Service Bulletin

Subject: Intermittent Service SIR System Indicator On and/or DTC B0014-04 Driver Seat Side Air Bag Deployment Loop Open

Brand:	Model:	Model Year:		VIN:		Engine:	Transmission:
		from	to	from	to		
Chevrolet	Spark EV	2014	2015	SOP	FC810077	All	All

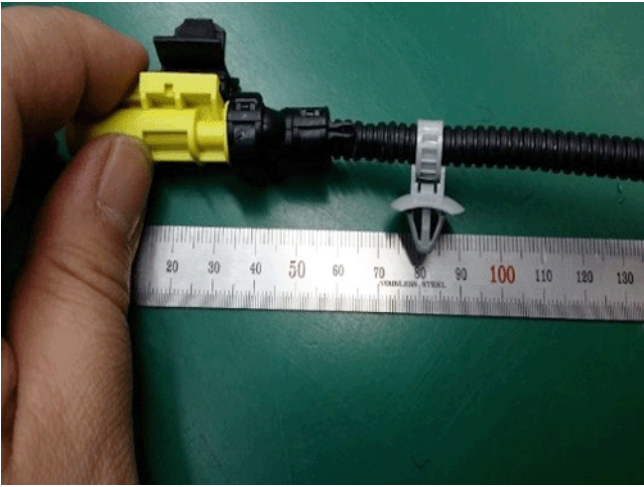
Condition	Some customers may comment on an intermittent SIR System AIR BAG indicator on. Upon investigation a technician may find DTC B0014-04 set in the Inflatable Restraint Sensing and Diagnostic Module (SDM).
Cause	This may be caused by the driver side airbag connector under the seat rubbing on the floor carpet causing the connector to have a loose connection, causing the light to come on and set a DTC.

4. Push in the cable locker using a pick or awl as illustrated above to loosen the cable tie so that it can be moved.

5. Once the cable tie is loose enough, move the cable tie 80 mm (3.15 in) from the end of the connector as illustrated above.
